## BELLAIRE PROPERTIES INC. (CARSON'S CREEK) PURCHASER EXTRAS

### LOT # 019 P.E #002 - Model - TEMAGAMI - 3350 - PHASE 5

#### Schedule B-3 – Purchaser's Extras

PURCHASER(S): CAN MUI HO LOT NUMBER: 19 PHASE: <u>5</u> MODEL: TEMAGAMI (3350)

Car Tandem **3068** sq.ft. - includes 478 sq. ft. of  $\Box$  LOT 5-19, PH5, STRUCTURAL OPTIONS - PE002 PURCHASER: Can Mui Ho (Jun 30, 2022 00:01 EDT)

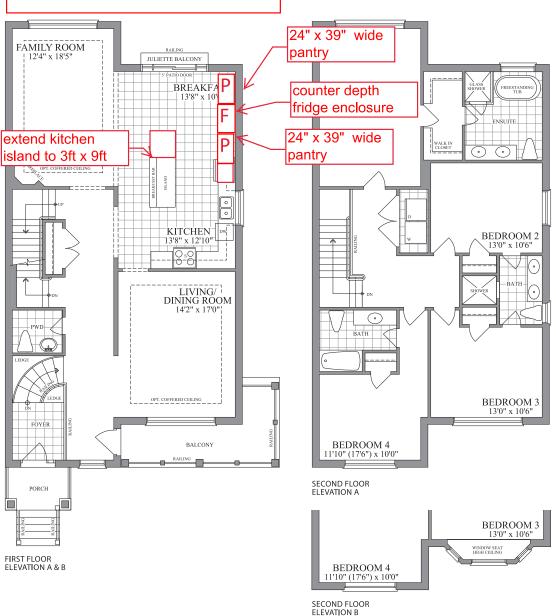
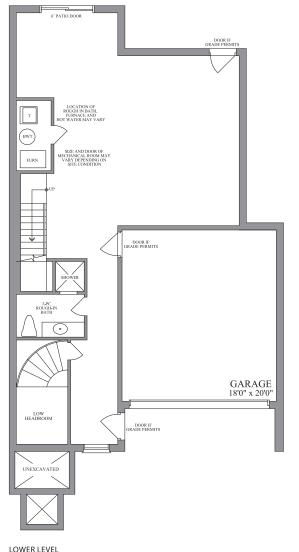
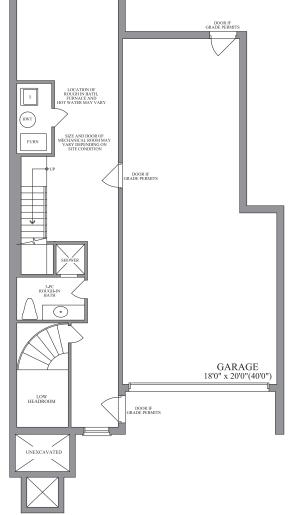
No.				
1	*Provisions to cabinetry to accommodate future chimney hood fan/exhaust fan above future stove/range in kitchen area.  *Note: Not all models can accommodate this change.  *Builder will try to accommodate centering the vent as best as possible. Purchaser must provide all specifications for future Chimney Style Hood fan/Exhaust Fan as soon as possible. This item must be decided prior to framing stage, otherwise may be considered too late.			
2				
	Free-Standing Range in the kitchen area. Price is based on Vendor's standard countertop.			
	Purchaser must provide model Specifications that show install and cut out instructions for the			
	range must be provided at interior colour selection appointment.			
	*Note: A slide-in range fits flush with the countertop and the cooktop portion slightly protrudes which rests on top of the countertop on either side. An additional piece of countertop behind the range is required, unless otherwise specified by the manufacturer.

3	Cost to Provide Black Exterior railing at front elevation in lieu of standard.			
	*Based on standard elevation			
	*Note, due to lot grading some elevations may not require any railing at stairs or porch, in the			
4	event that railing is not required purchaser will be credited back amount charged  Cost to provide smooth ceilings in lieu of stippled ceilings - main floor			
4	Cost to provide smooth centings in hed of supplied centings - main floor			
5	<ol> <li>Provide and install two pantries – each 2ft deep by 39" wide</li> <li>Fridge opening – 37" wide – to be centered between the two pantries.</li> </ol>

3. Extended space between the sink and 1 <sup>st</sup> pantry (approx. 1ft)			
	4. Counter depth fridge enclosure with extended upper cabinet above fridge.			
	<ul><li>5. Kitchen Island (standard is 3ft wide by 6ft long, which includes the overhang for the breakfast bar)</li></ul>

a. Extend kitchen island to 3ft (36") x 9ft (with breakfast bar)			
	b. Extend kitchen island granite depth to a total of 44" (36" standard depth with 8" overhang)

6. Additional granite for kitchen extension including the island.			
	7. Price is based on standard cabinetry and standard granite.			
	8. All upper cabinetry and pantry to be extended to the bulkhead – standard 9ft ceilings.			
	Extra's Subtotal:			
	H.S.T.			
New Total:				
Less Bonus Package (if Applicable)				
	TOTAL:			
Amount to be Added to the Purchase Price as an Adjustment on Closing:				
	TOTAL
